Access Compliance Report

Public Rights-of-Way

Intersection ID: 28385	Main Street: COMMONS_CROSSING_DR	Cross Street: HIGHLANDS_CROSSING_DR	Location: SE
ADA ID: CB9482B68224	Ramp Type: PerpDiag	Initial Pass/Fail: Pass	Overall Compliance: No
Severity Score: 15.25			
Codes/Mitigation Info/Possible Solution		Field Measurements/Component Compliance

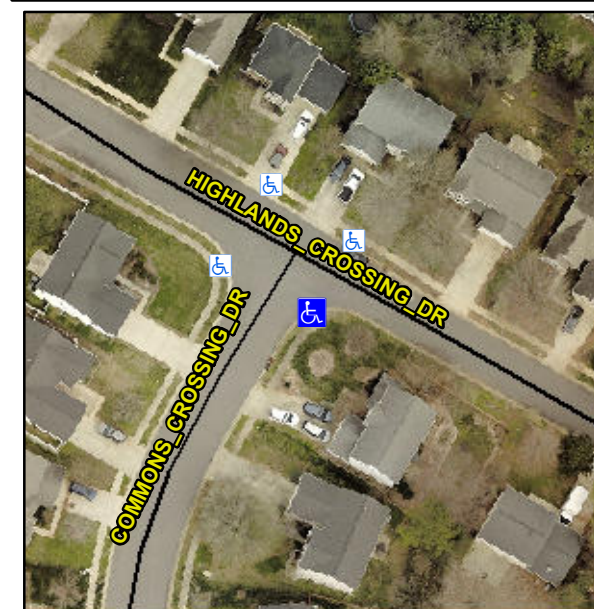
Not Found, R304.5.3, R305, R304.5.4

Compliance	Description	Data	Compliance	Description	Data
N/A	Ramp Length (in)	45.0	Yes	Ramp Slope (%)	6.7
Yes	Ramp Width (in)	48.0	No	Ramp XSlope (%)	3.5
N/A	Flare Type LT	Sloped	N/A	Flare Type RT	N/A
N/A	Flare Slope LT (%)	11.6	Yes	Flare Slope RT (%)	6.1
N/A	Flare Traversable LT?	No	N/A	Flare Traversable RT?	Yes
Yes	Landing Length (in)	48.0	No	DWS Provided?	No
Yes	Landing Width (in)	48.0	N/A	DWS Contrast?	No
Yes	Landing Slope (%)	1.7	N/A	DWS Length (in)	N/A
No	Landing X Slope (%)	3.9	N/A	DWS Full Width?	No
N/A	Landing Curb? (Y/N)	No	N/A	DWS Offset (in)	N/A
N/A	Shared Landing?	No			
Yes	Gutter Ponding?	No	No	Gutter Slope (%)	11.7
Yes	Gutter Lip Ht (in)	0.0	Yes	Gutter X Slope (%)	2.0
N/A	Painted X Walk1?	No	N/A	Painted X Walk2?	No
	X Walk 1 Direction	To NW		X Walk 2 Direction	To SW
N/A	X Walk 1 Width (in)	N/A	N/A	X Walk 2 Width (in)	N/A
	X Walk 1 Slope (%)	5.4		X Walk 2 Slope (%)	0.2
	X Walk 1 X Slope (%)	0.4		X Walk 2 X Slope (%)	4.1

Remove & Replace Curb Ramp With Two New Directional Ramps or Equivalent. Remove & Replace Gutter.
